July 30, 2025

City of Pompano Beach
100 W. Atlantic Boulevard
Pompano Beach, FL 33060

**Re: Plan Review – Costco PZ25-12000023
Comment-Response Letter**

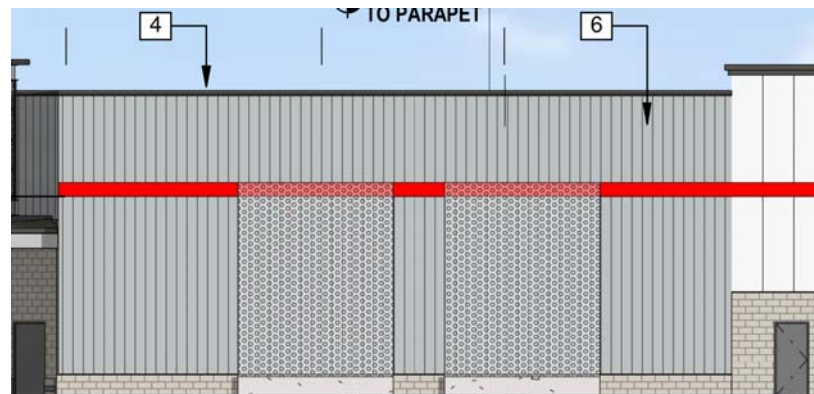
- ii. Columns or pilasters that are at least eight inches deep and at least eight inches wide, and have a height equal to at least 80 percent of the facade's height;

Response: Understood.
